171 Forest Way Belrose,
NSW – Seniors Living
(Belrose Pavilions)

Access Review
Final v2

29 June 2022

Figure 2. Level 7 Principal Pedestrian Entrance linkage from boundary to Lift lobbies 1 and 2.

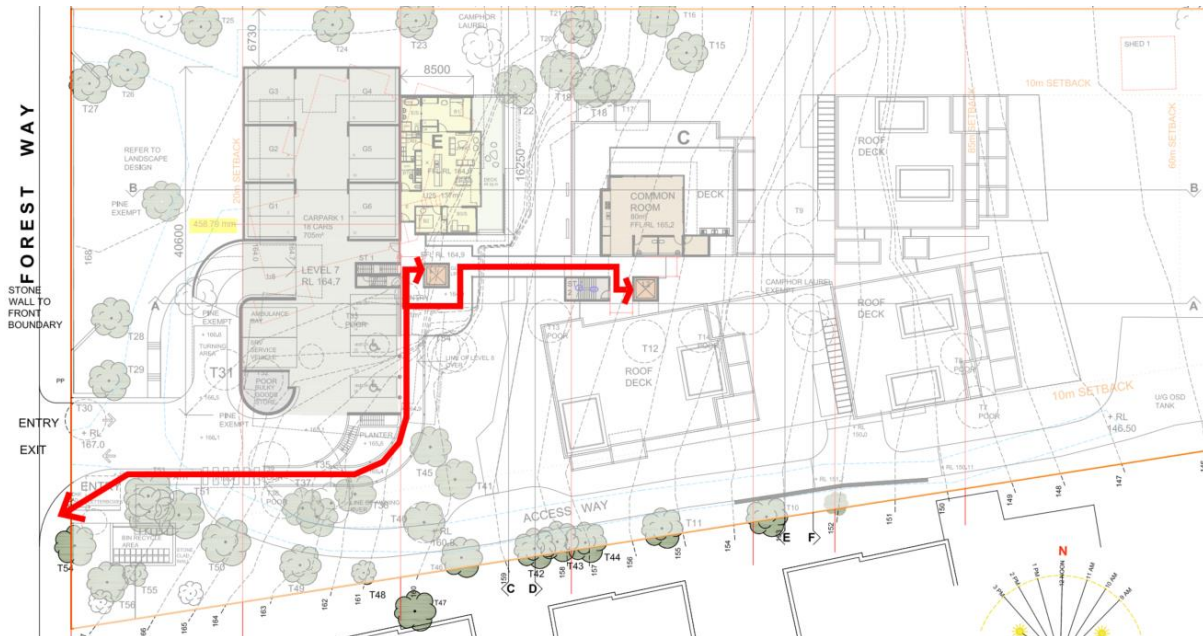
MGAC has reviewed the drawings and documentation in relation to the aforementioned requirements. On the basis of the current level of detail all access requirements achieve

compliance via from Forrest Way allotment boundary to 6 blocks, linkage occurs on level 7 via lifts 1 and 2.
